Panorama Towers

**State Significant Development Application
SSD-10321
Residential Development at 89 John Whiteway Drive GOSFORD**

Figure 1: Extent of Rock catcher and Geo-textile fencing.

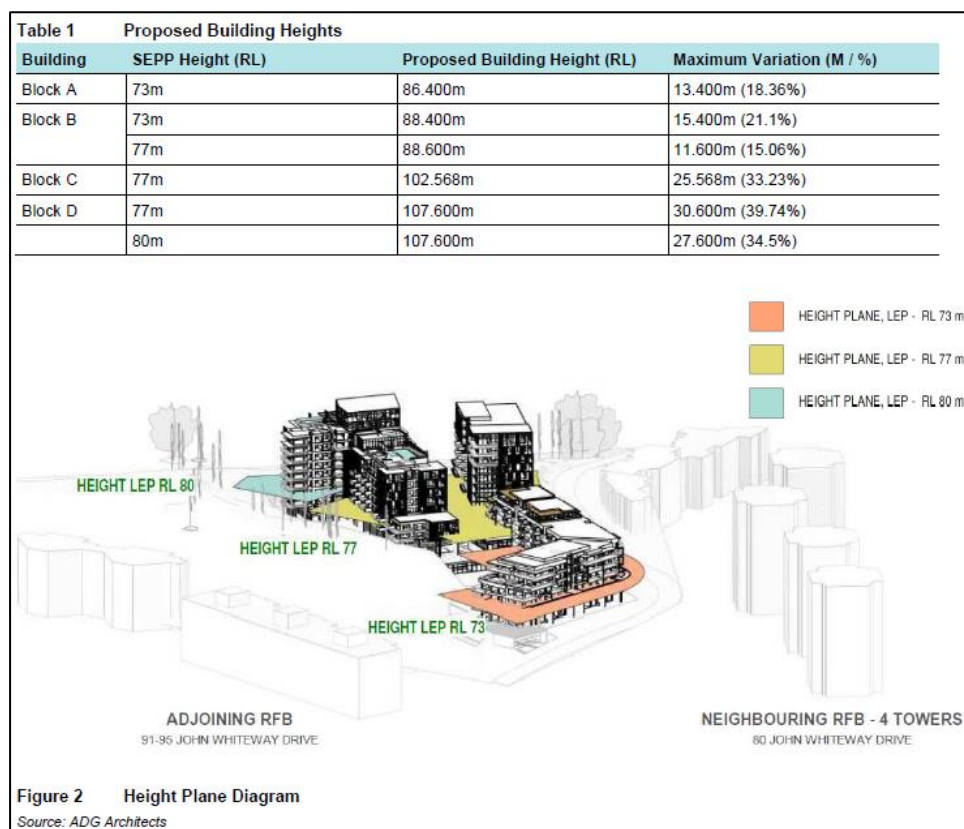
The applicant's Geotechnical documentation only speaks of rock catching fencing on the boundary of the site which have been identified in a drawing from their Preliminary Construction Management Plan – Figure 1, as shown below.

We strongly object to the fact that this fencing is at the top of the quarry cliff faces and does not take into consideration rock falls that would occur below this line as a result of the proposed excavation and removal of the ridge line.

The aerial image of the Panorama site has been superimposed on top of Figure 1 to clearly show the parking, gardens and swimming pool which was incorrectly positioned in figure 1 and can now be seen as directly at the base of the quarry cliff face.

The drawing clearly shows in yellow the rock catch fence which coincides with the cliff faces.

We strongly object to the fact that the full extent of the Panorama Towers building has not been considered. This has been highlighted in red and clearly shows the vulnerability of this neighbouring property.

The extent of the area marked in red shows areas of daily use where residents access their vehicles, their personal storage areas and use the swimming pool on a daily basis. It is expected that should such excavation work be permitted that the applicant be fully insured and held liable for any damage to property and belongings, or injury to people utilising these areas. The authorising authority should also be held responsible should this be approved, as this is an obvious disaster waiting to happen.
